TOYOTA TECHNICAL SERVICE BULLETIN

REF.: BRAKES
 NO.: BR94-004
 DATE: JUNE 24, 1994
 MODEL: ALL MODELS

INTRODUCTION OF NEW DISC BRAKE PAD KIT

SUPPLY PARTS CHANGE:

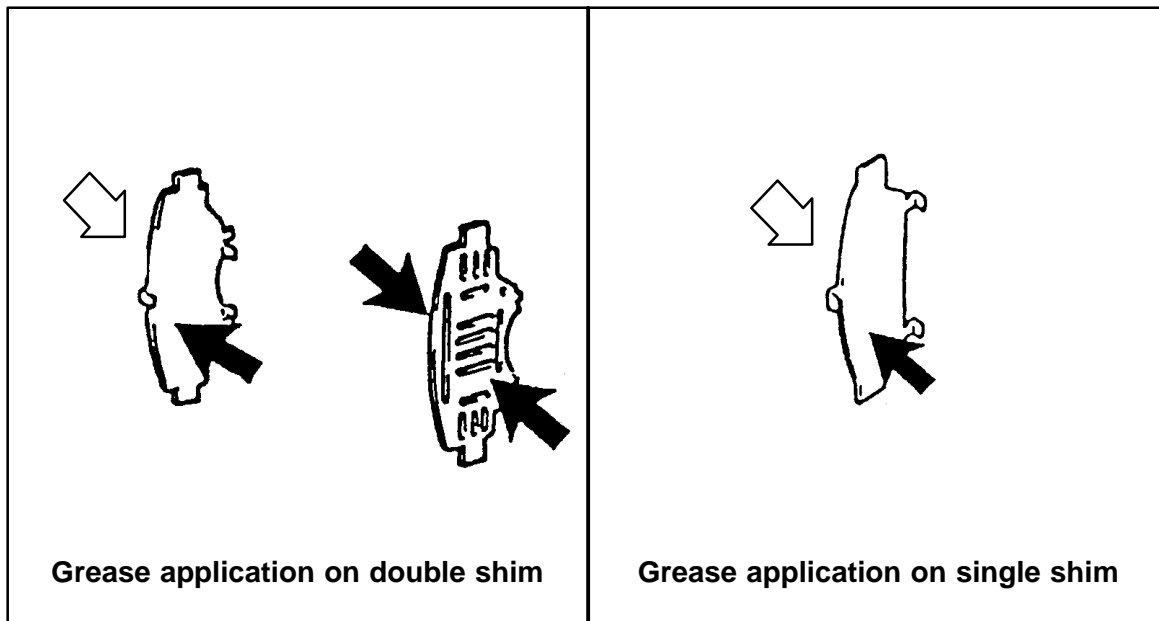
New brake pad kits (minus hardware) and shim grease for the front and rear brakes are now available separately. The current full kit and other related parts will also continue to be available.

CURRENT		NEW
U N C H A N G E D	Full Kit		Unchanged →	
	Shim		Unchanged →	
	Shim		Unchanged →	
	Anti-Squeal Spring		Unchanged →	
	Support Plate		Unchanged →	
	Wear Indicator		Unchanged →	
N E W	Pad Kit	New →	
	Shim Grease	New →
